## ARCHITECT'S ADDENDUM

ADDENDUM NUMBER: 02

RE: 1<sup>st</sup> Midwest Bank Sheriff Renovation  
Will County

Subject: Addendum No. 02 to the Construction Documents for the 1<sup>st</sup> Midwest Bank Sheriff Renovation.

5 SILL DETAIL - WOOD FRAME @ INTERIOR WINDOW  
 1 1/2" = 1'-0"

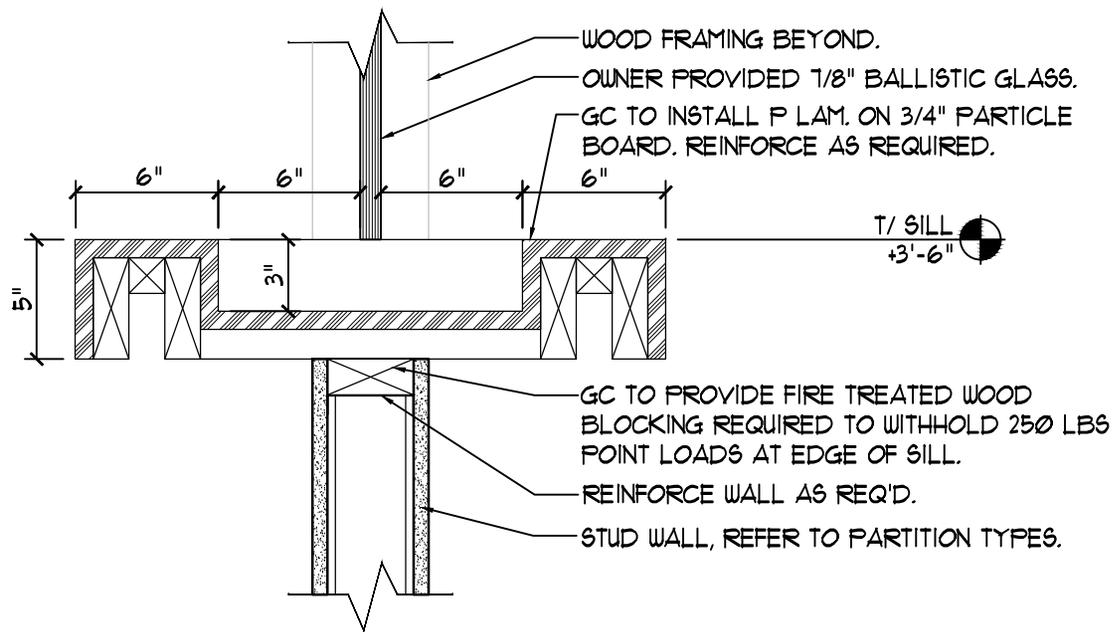
4. Please advise if the owner shall be providing the stainless steel sill with detail tray and voice panel, along with the 7/8" ballistic glass per detail 5/A6.2. If so, is the general contractor providing the installation, or are we only responsible for providing rough openings with fire treated wood blocking? If the GC's are responsible for the purchase and installation of the steel sill, can you please provide a specification at your earliest convenience.

- Contractor is to provide the sill/pass through(see sketch attached) and install the sill and glass. No voice panel is required.
5. Our insurance company can certainly include the above entities as "additional insured's" but not "named insured's" as indicated. Can you please clarify this question.
